Search Result for HOWARD COUNTY

MARYLAND GROUNDWATER POLLUTION CONTROL AND PREVENTION SYSTEM

Subject: Daedalean Associates, Inc.
Two Story Office Building
Springlake Research Center
15110 Frederick Road, Woodbine, Md.
Permit Serial #41776 (Amendment)
SDP 79-162

3/8/99 The Woods @ Ridgeview - Perc Cert

Well Site Inspection
Daedalus Estates
Office Complex Building
- Located in back of Pond

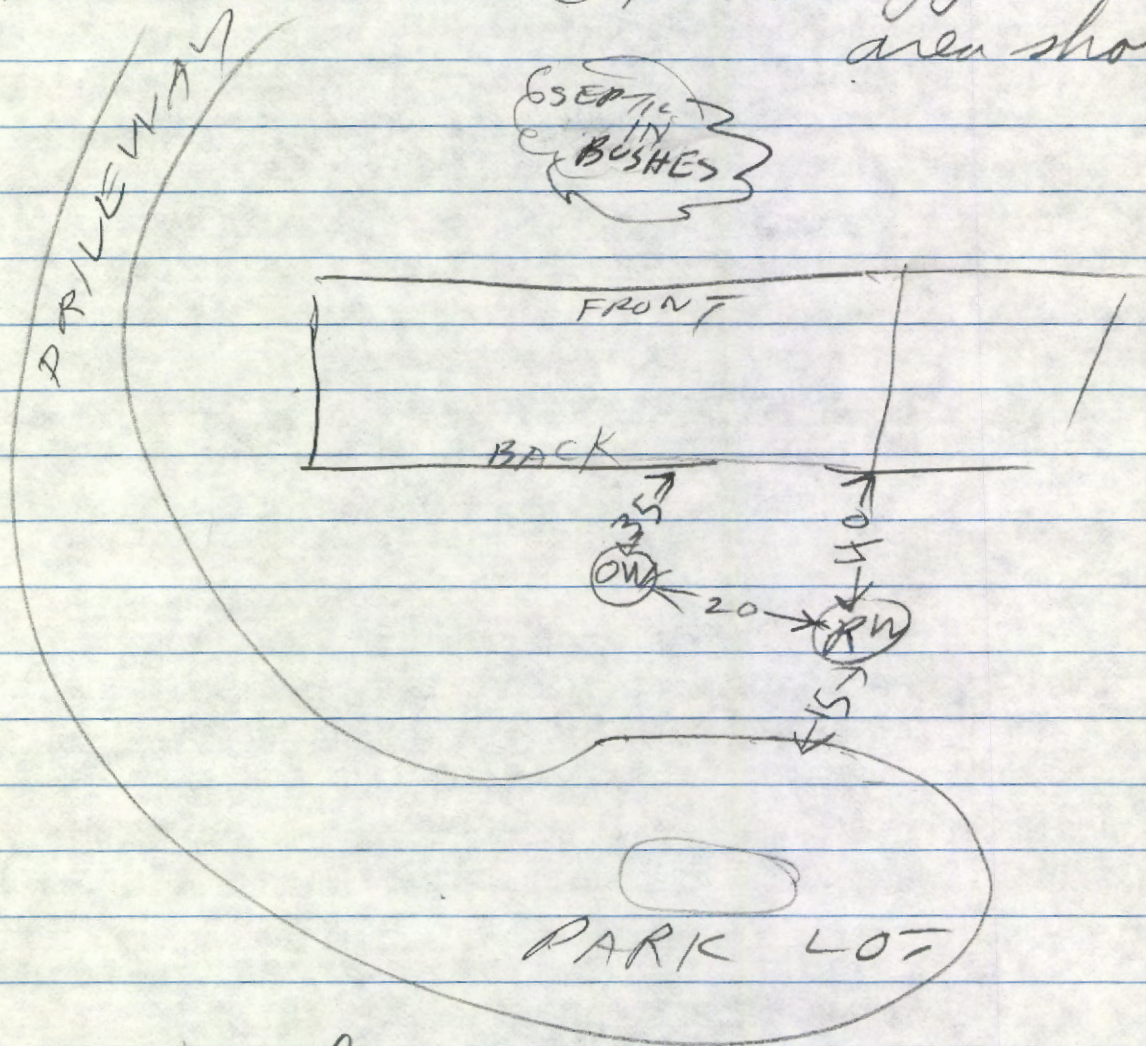
Well site OK in approx
area shown

OW = old Well
RW = Proposed Well
(replacement)

Appears to be well for admin. building
(office)
